UNITED STATES PATENT AND TRADEMARK OFFICE

APPLICATION NO.	FILING DATE	FIRST NAMED INVENTOR	ATTORNEY DOCKET NO.	CONFIRMATION NO.
10/788,692	02/27/2004	Christopher J. Norman	STE01 P-1165	7031
277	7590	01/11/2007	EXAMINER	
PRICE HENEVELD COOPER DEWITT & LITTON, LLP			HAWK, NOAH CHANDLER	
695 KENMOOR, S.E.			ART UNIT	PAPER NUMBER
P O BOX 2567			3636	
GRAND RAPIDS, MI 49501

Office Action Summary	Application No.	Applicant(s)	
	10/788,692	NORMAN ET AL.	
	Examiner	Art Unit	
	Noah C. Hawk	3636

DETAILED ACTION

Tsai, Figure 4

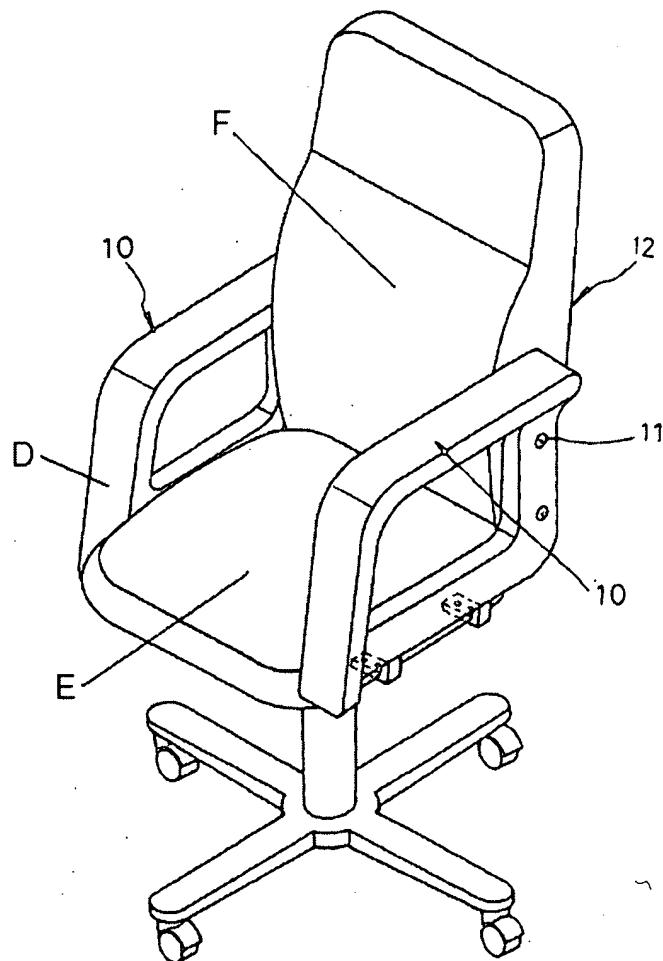
6. Claims 1, 8, 9, 11 and 12 are rejected under 35 U.S.C. 102(e) as being anticipated by Tsai in US Patent 6948775. Tsai teaches an adjustable armrest for a chair comprising an armrest base member (4), a support member (3) slidably coupled to the base member for movement in first and second directions (best seen in Figure 4 and 5) relative to the base between first forward (Best seen in Figure 4) and second rearward (Best seen in Figure 5) positions relative to the base and biased by a spring (A) into the first position, a device selectively retaining the support member in the second position, the device including a catch (B) and a movable retaining member (C), the retaining member disengaging from the catch upon movement of the support member in the rearward direction (if the support member is moved rearward, the retaining member C will disengage from the indentation B). Tsai further teaches that the support member is rotatably coupled to the base (Best seen in Figure 6) to permit rotational adjustment about a generally vertical axis.

Tsai, Figure 1

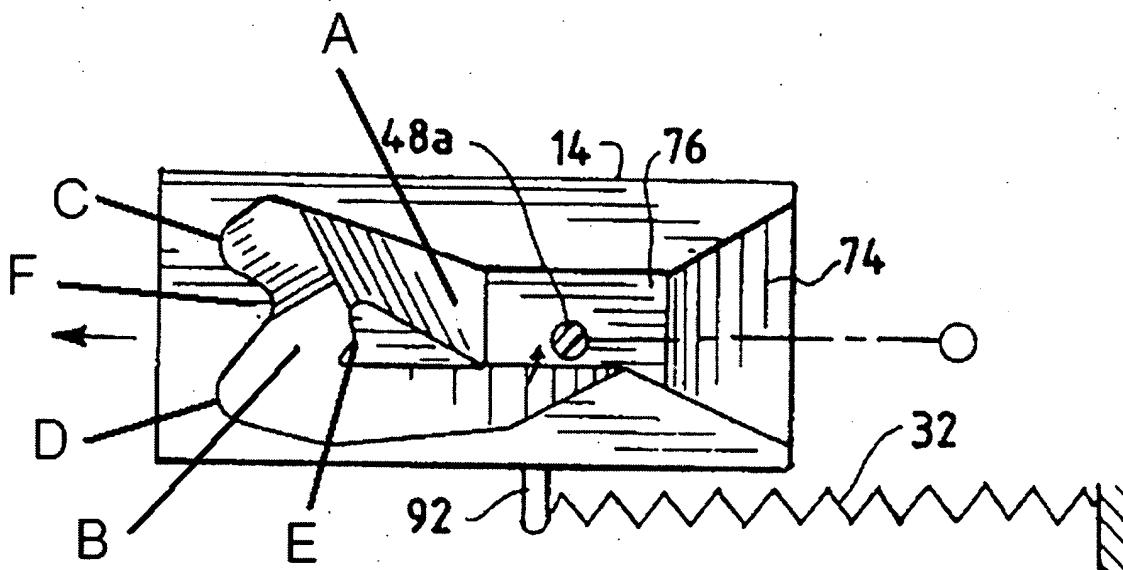
7. Claims 21, 26 and 28 are rejected under 35 U.S.C. 102(e) as being anticipated by Tsai in US Patent 6948775. Tsai teaches a seating unit comprising a frame (D) a seat (E) a backrest (F) and a pair of armrests (10). Tsai further teaches details of the armrests (Shown in Figures 2-6) wherein they are movably mounted to the frame (Best seen in Figures 5 and 6) for movement between forward (Figure 4) and rearward (Figure 5) positions wherein the armrests are biased (by springs A) into the forward position and each includes a device (C) selectively retaining the armrests in the rearward position wherein the movement of the armrests releases the device (if the support member is moved rearward, the retaining member C will disengage from the indentation B) such that the armrests move to the forward position due to the bias (the spring will tend to rebound the support member toward the first position). Tsai further teaches that the armrests include a base member (4) connected to the frame (2) and a support member (3) slidably coupled to the base member and rotatably coupled to the base member to permit rotational adjustment.
